INTERIM MEASURES WORK PLAN FOR SOLID WASTE MANAGEMENT UNIT 25 (SWMU
25) WITH TRANSMITTAL CNC CHARLESTON SC
7/7/1999
SOUTH CAROLINA DEPARTMENT OF HEALTH AND ENVIRONMENTAL CONTROL

Re: Interim Measures Work Plan for SWMU 25, Dated April 9, 1999, Located in
Zone E Charleston Naval Complex SCO 170 022 560, Revision 1.0, Received
June 29, 1999.

RE: Charleston Naval Base (CNAV)
Charleston County, South Carolina
SC0 170 022 560

Interim Measure Workplan
Zone E, SWMU 25
Received 29 June 1999, Revision 1

FIGURE 2-23
SLMU #17
OIL SPILL AREA
(FIGURE TAKEN FROM REF. 2)

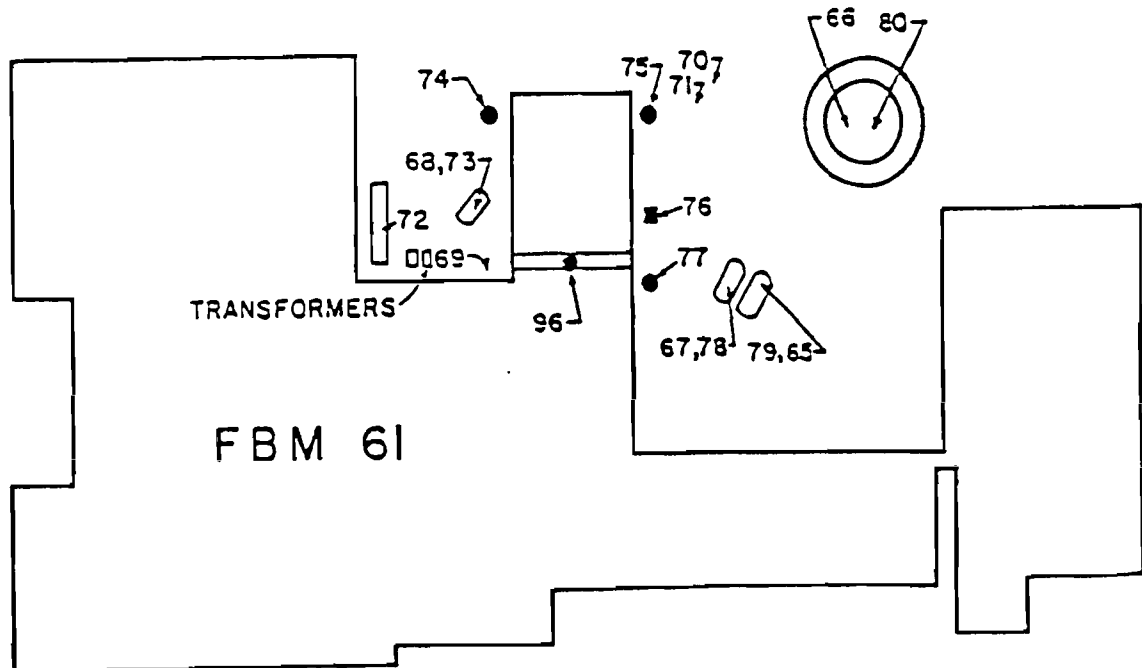
Figure 2-23 in the 8-5-1992 RFI Work Plan (copy enclosed) indicates the inside sump is contaminated with 78 ppm PCBs. The interior soil borings must manage all IDW as hazardous waste until proven by confirmation samples.

8. Figure 2-23 in the 8-5-1992 RFI WP indicates several fuel tanks due east of the southwest sump. The status or fate of those tanks has not been addressed in any of the recent documents. The tanks may contribute to NAPL. Please update the status of the tanks.

Figure 3 - SWMU 163 DPT Vertical Profile Layout Grid

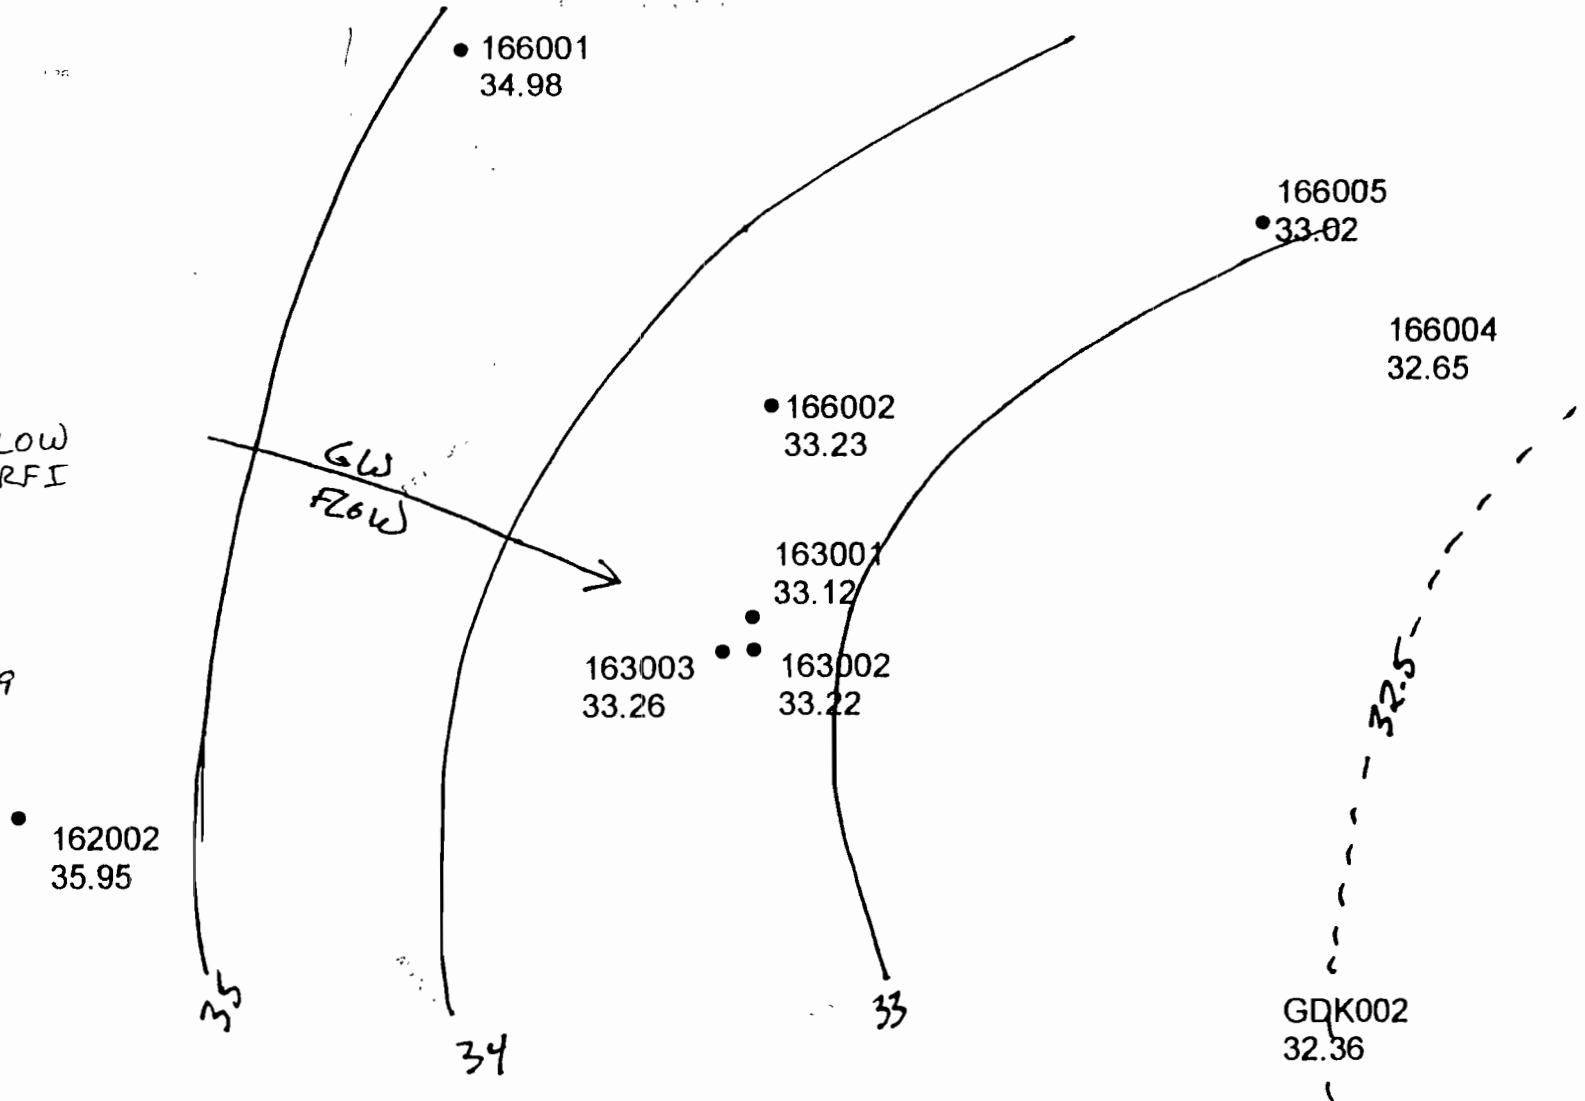
As per your request during our August 26th phone conversation, EnSafe is submitting a tentative strategy for vertical profiling of groundwater VOCs at SWMU 163 at the Charleston Naval Annex. Depicted in Figure 3 of the SCDHEC temporary monitoring well permit request submitted to you on August 17, 1999, is an initial inner and outer grid for vertical profiling. The inner 10 ft X 10 ft grid of nine vertical profiles surrounds the shallow monitoring well (163003) with the highest dissolved chlorinated solvent concentrations and lies in close proximity to the 10 ft X 10 ft X 2 ft concrete pit that served as a less than 90 day satellite accumulation area. The outer grid of eight vertical profiles spaced 30 ft X 30 ft apart will lie approximately 20 feet from the inner grid and will delineate the extent of any potential lateral migration of chlorinated solvents.

FIG. 4 Area 2 DPT Vertical Profiling Locations

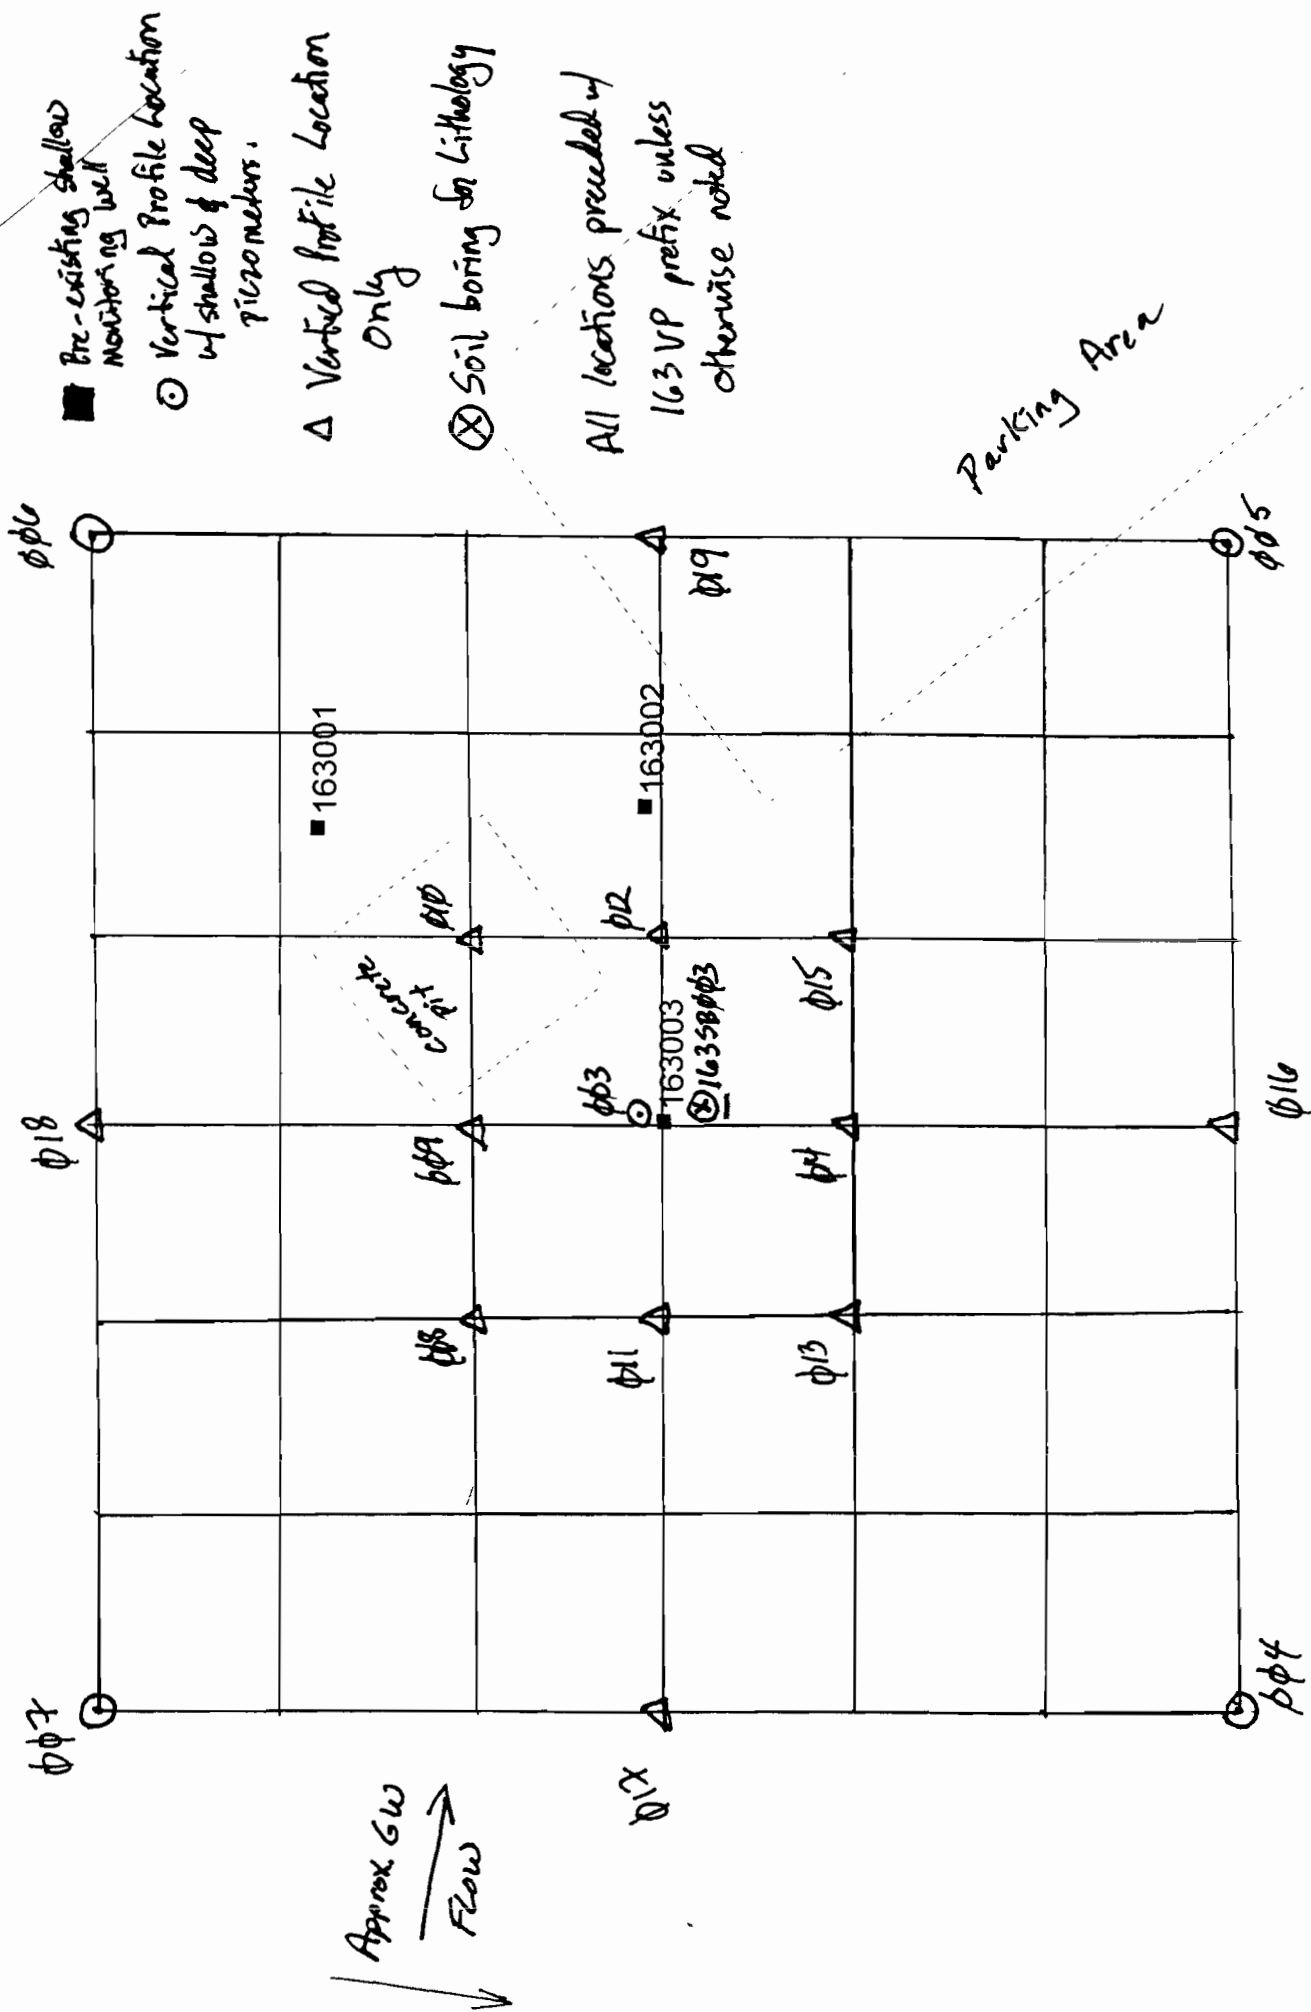
Since a mobile laboratory will be on-site to provide analytical results within 24 hours of sampling, EnSafe intends to bore additional vertical profiles or re-orient the initial grids should the analytical data and groundwater flow data warrant. A hypothetical example is shown in Figure 1 (attached). If the most southeastern profile point (ID of 163VP005) is contaminated, then an additional profile will be bored approximately 40 feet downgradient, which is twice the distance between the inner and outer grids. If this profile also reveals contamination, the distance will be doubled again and another profile will be bored 80 feet downgradient. This procedure will be used until low concentrations or non-detects are encountered. If necessary, the distance between a contaminated and non-detect profile will be halved and an additional vertical profile advanced in an attempt to determine the leading edge of contamination. Should several outer grid points reveal contamination, more than one additional downgradient profile will be bored at the 40 foot distance. However, in this scenario, additional sampling will focus on delineating the extent of contamination away from the profile with the highest solvent concentrations.
